CONSTRUCTION BULLETIN

Issued By: Julia Hoban, Red Architecture

Project: Walnut Hills – Store 4870 – CMG1144

Issued on: 05/09/2024 Regarding Construction Documents dated: 05/08/2024

1
G001
LIFE SAFETY PLAN
1/4" = 1'-0"

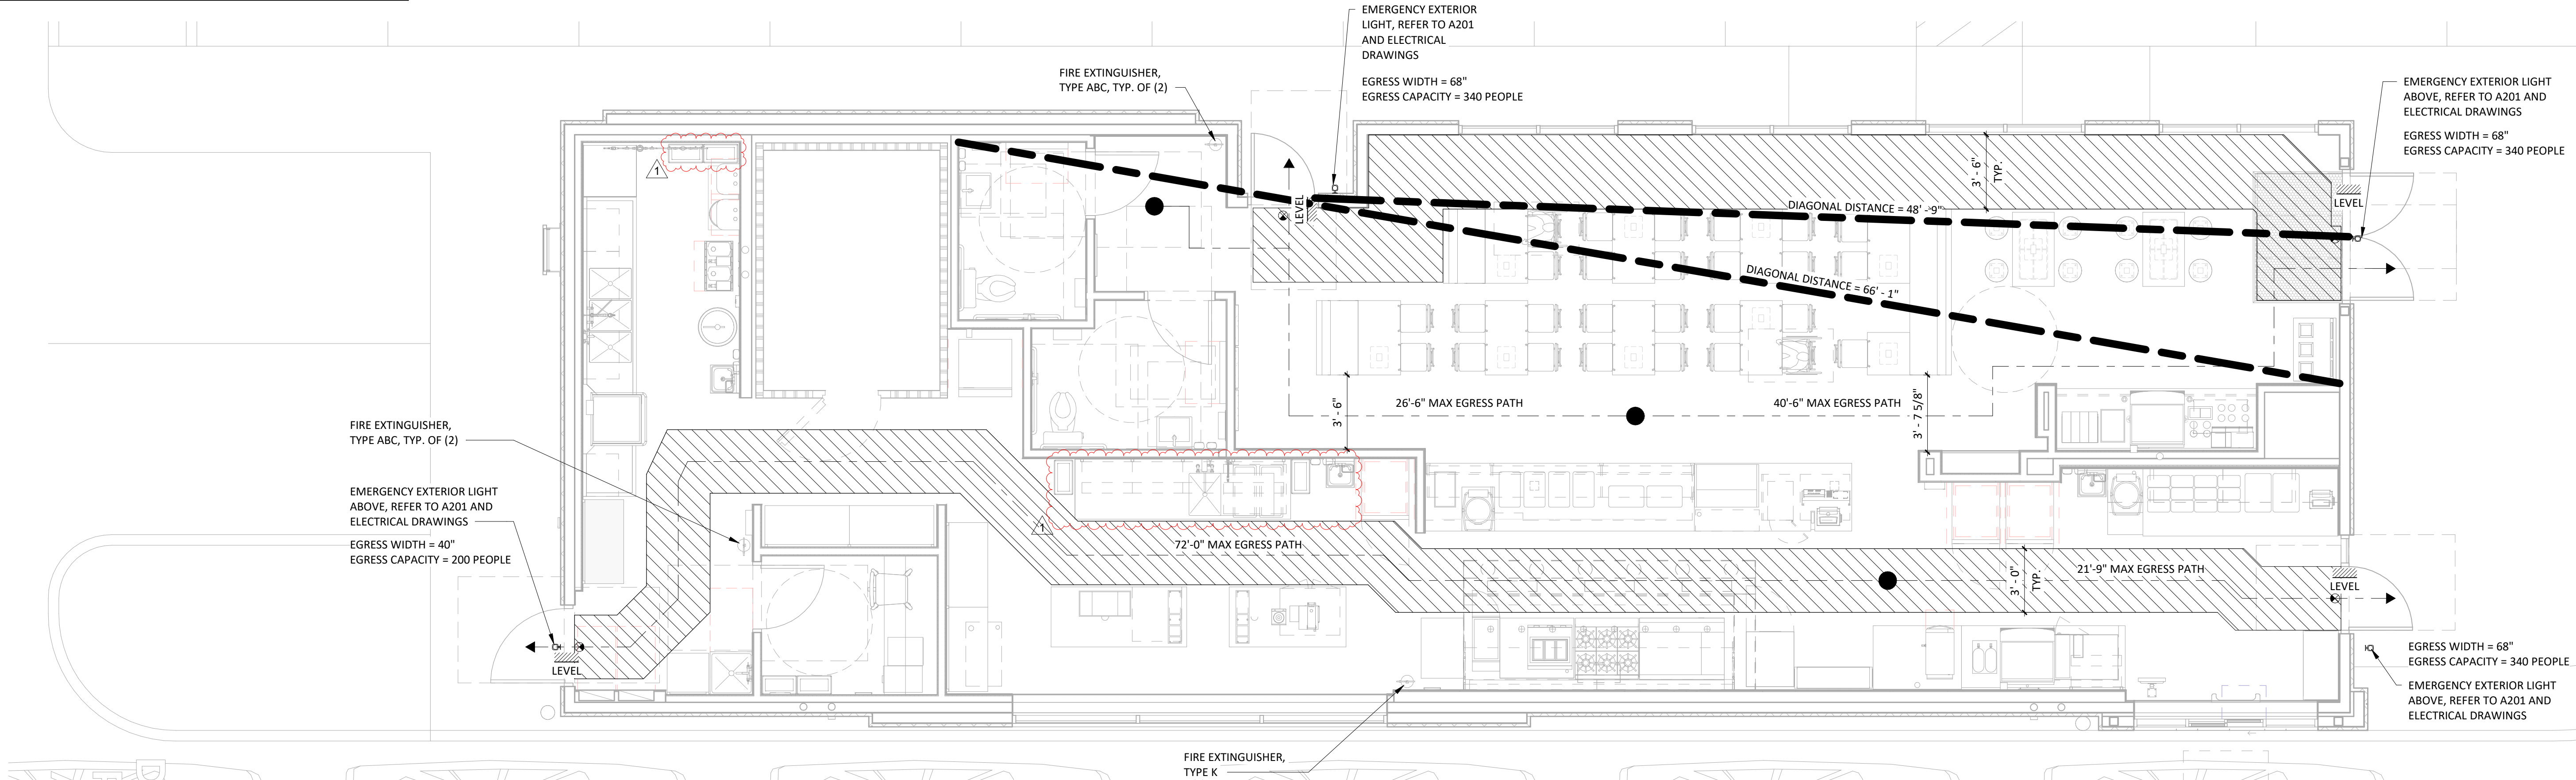
#1	Revision	X	Per Direction of: <i>permitting jurisdiction</i>
	Correction		
<i>The hand sink located in the prep area shifted to the other side of the prep sink per comments from the health department. The prep sink and associated floor sink below shifted slightly also to accommodate.</i>			
<i>The following sheets were revised and clouded as Revision 1: G000, G001, A101a, A130, A702, P100, P110, E110</i>

ROOF PLAN

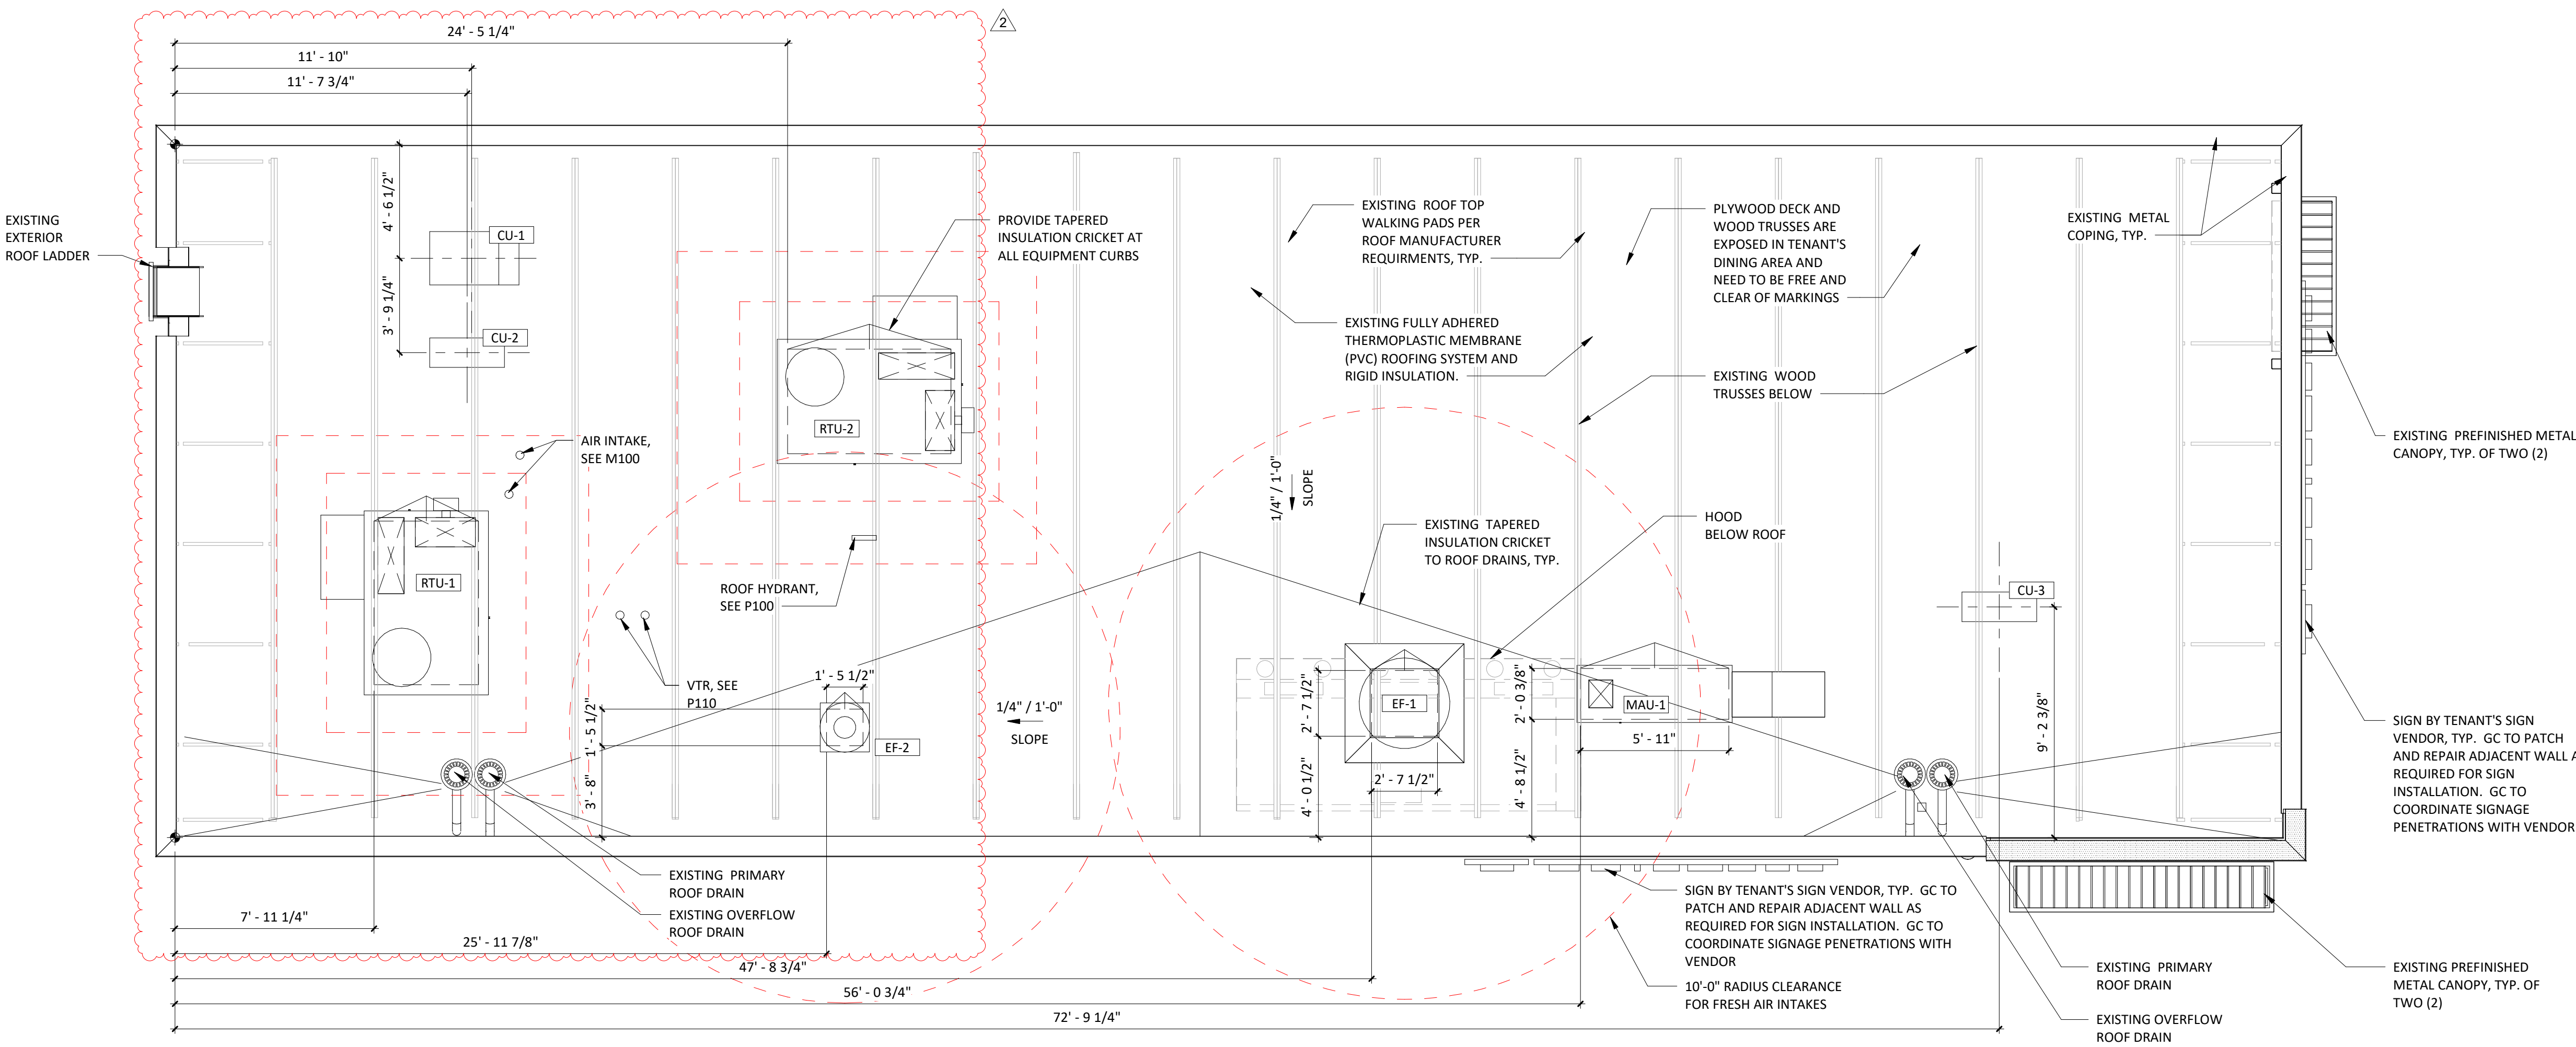
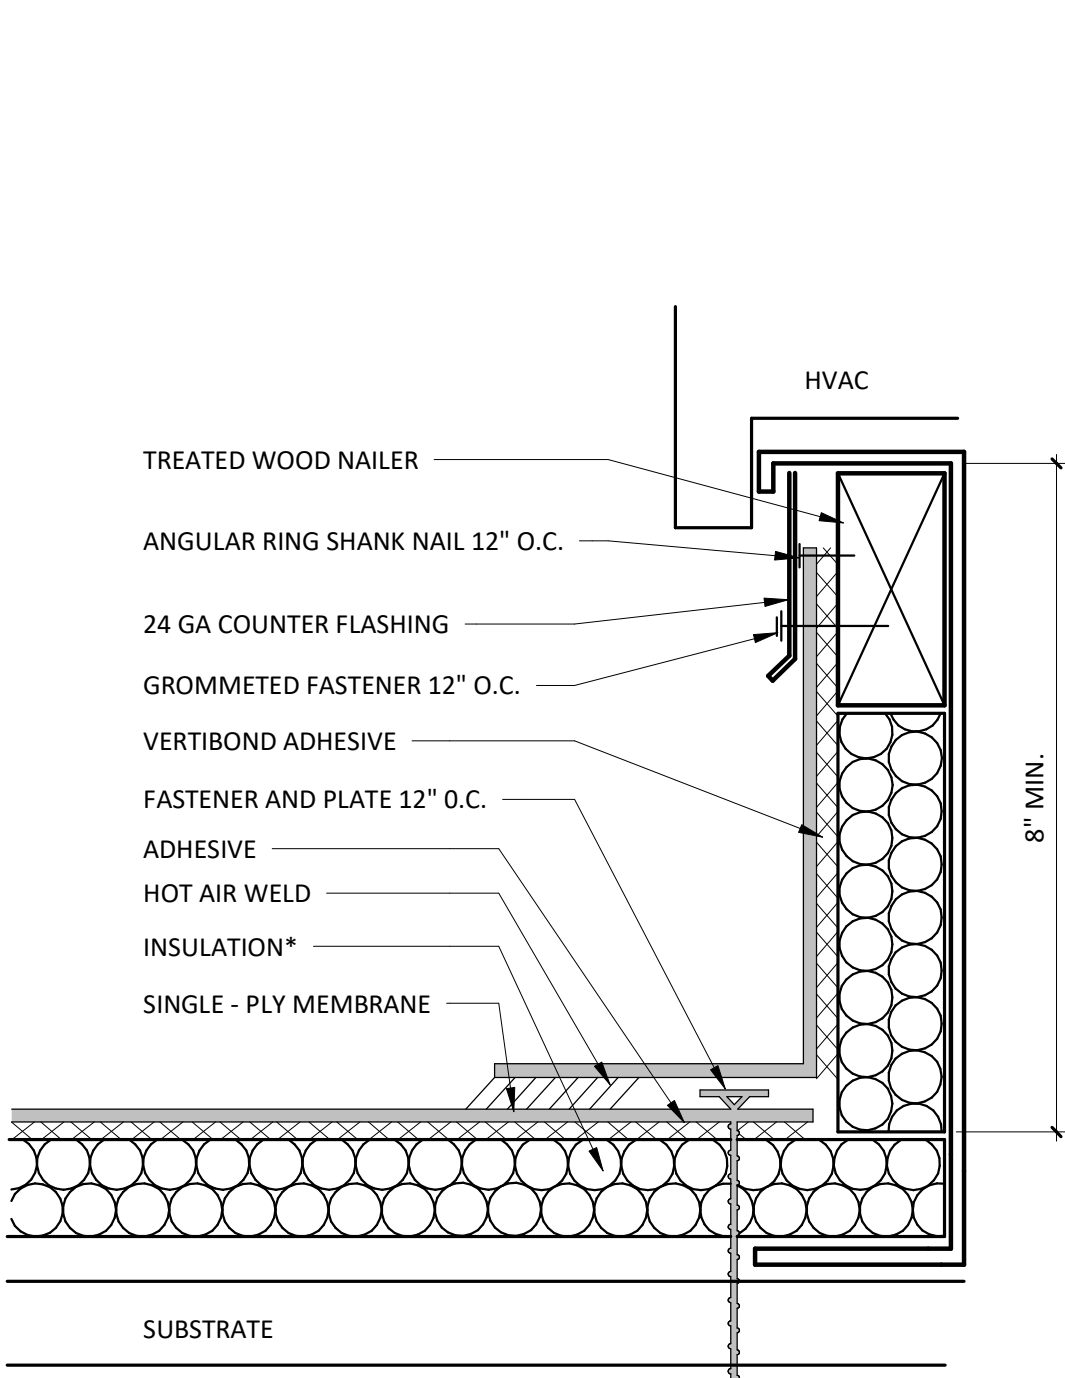
#2	Revision	X	Per Direction of: <i>permitting jurisdiction, owner</i>
	Correction		
<i>NL was redefined to mean Normal Power Egress Lighting. Light fixture P6 was added to the NL circuit.</i>			
<i>Conductor and conduit sizes were added to the main distribution diagram.</i>			
<i>RTUs were swapped from York units to Carrier, rooftop plan was adjusted.</i>			
<i>The following sheets were revised and clouded as Revision 2: G000, A140, M100, M600, P100, E010, E100, E110, E600, E710</i>
